**ALDI Stores Pty Ltd C/- Ekistics Planning & Design**

Demolition of two (2) dwellings and construction of a supermarket (ALDI – shop) with associated signage, car parking, earthworks and landscaping and removal of a regulated tree

**41-47 Park Terrace and 10-14 Mawson Street Salisbury**

361/E013/18

Figure 1: Site plan and recommended acoustic treatments.

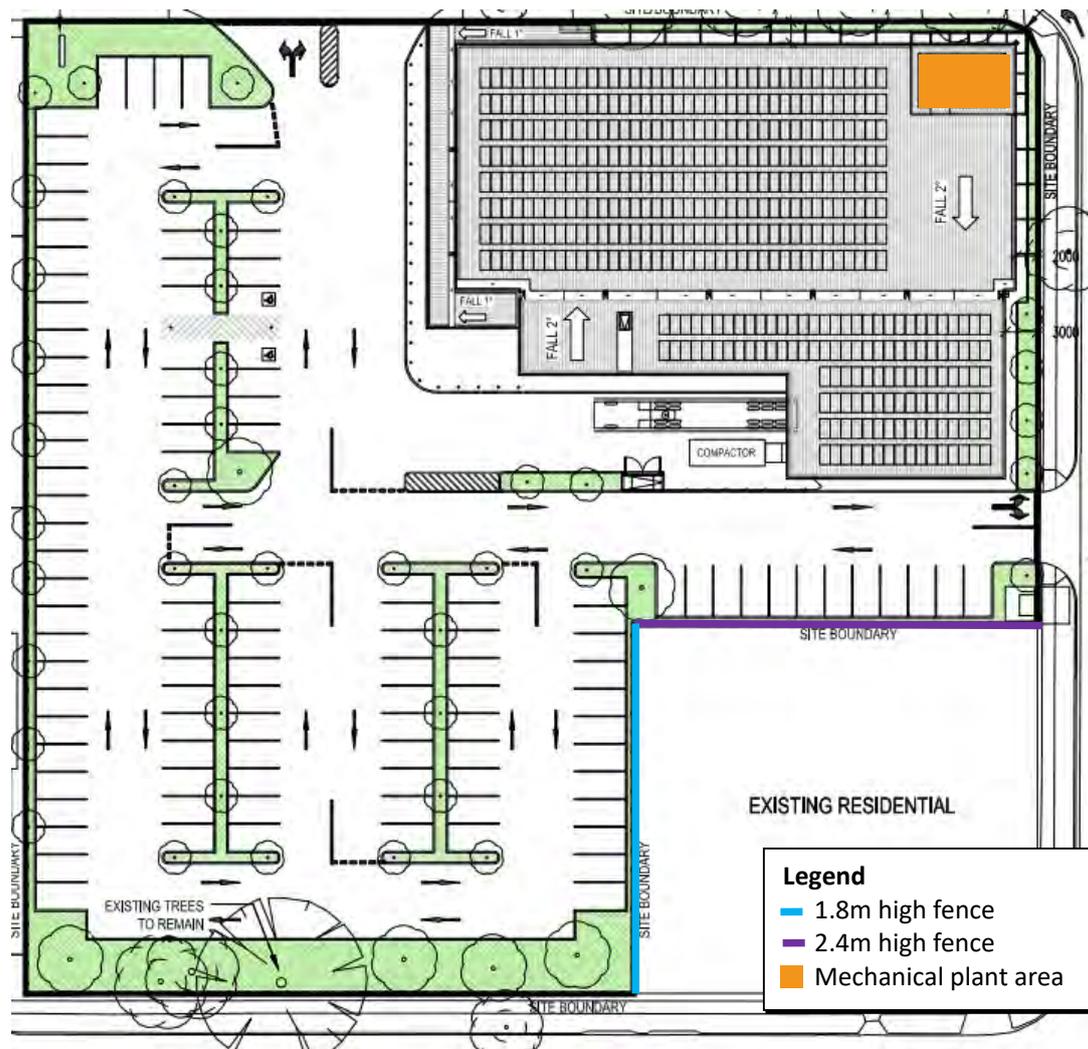
- Construct 1.8m and 2.4m high fences for the extents shown in Figure 1 as **BLUE** as **PURPLE**, respectively. The barriers should be constructed from a solid material such as sheet steel “Colorbond” or similar, and be sealed airtight at all junctions including joins to the building, ground, and other fences;
- Locate all mechanical plant on the roof of the ALDI building within the designated area indicated in **ORANGE** in Figure 1; and,
- To ensure there is not unreasonable interference from noise from rubbish collection, it is recommended that the hours of rubbish collection from the site be restricted to the hours of Division 3 of the *Environment Protection (Noise) Policy 2007*. That is, only between the hours of 9:00am and 7:00pm on a Sunday or public holiday, and 7:00am and 7:00pm on any other day.

**Figure 1: Modified T-Intersection (Egress only on minor approach)**

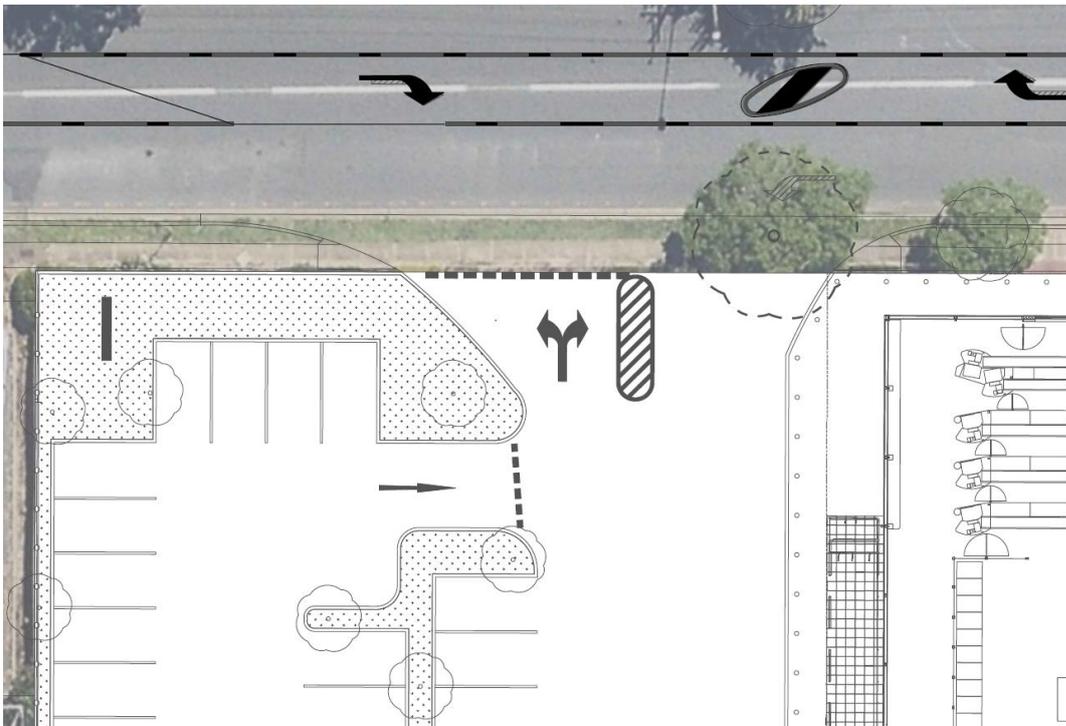
The internal three-way intersection has been amended. The minor approach leg has been converted from two-way movement to egress only. This removes the right turn decision point for vehicles who have immediately entered from Park Terrace. Figure 1 considers the changes made to the layout.

**Figure 2: Give-way on east and west approaches to 4-way intersection**

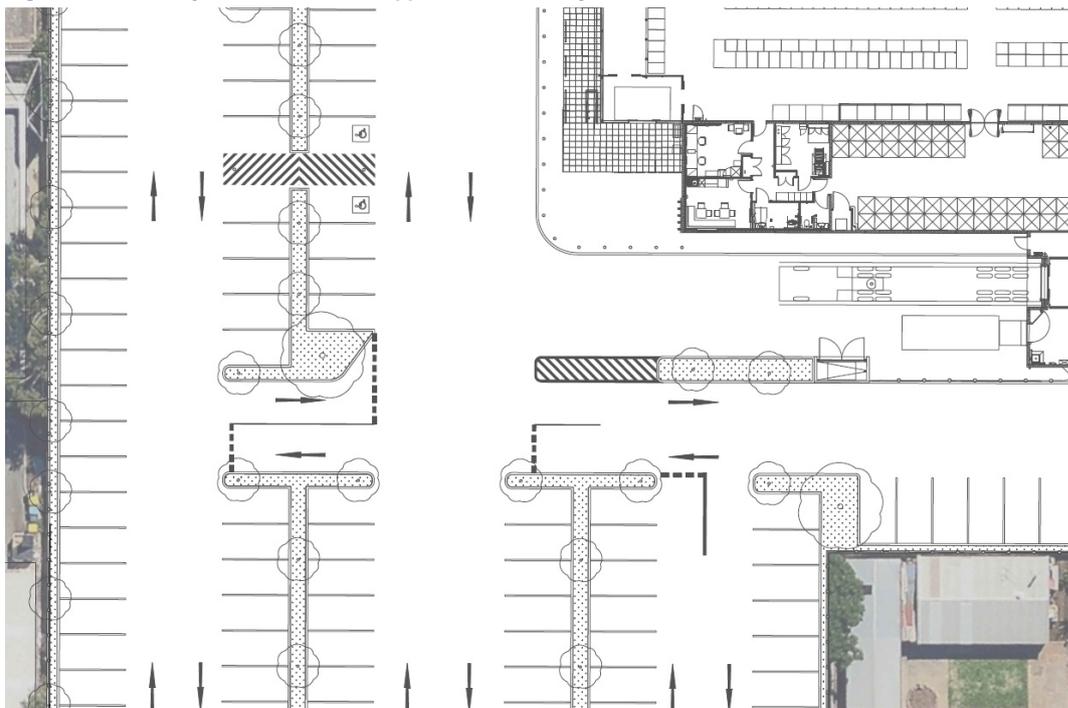
The four-way intersection within the site has been modified such that the east and west approaches are required to give-way to the north and south approaches. This ensures that the truck will have priority when reversing into the loading dock. Figure 2 shows the revised intersection concept.

Figure 3: Painted Intersection Configuration

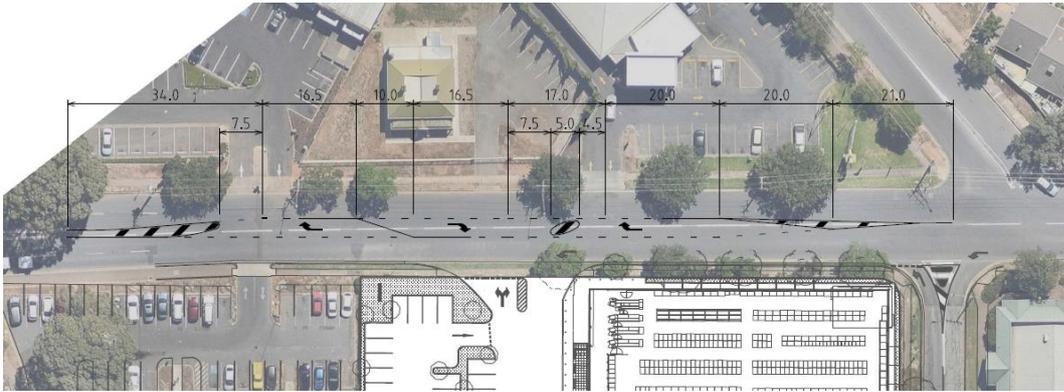
A dimensional layout plan for the proposed intersection treatment is shown in Figure 3. A detailed traffic control layout plan will be developed further during the detailed design phase.
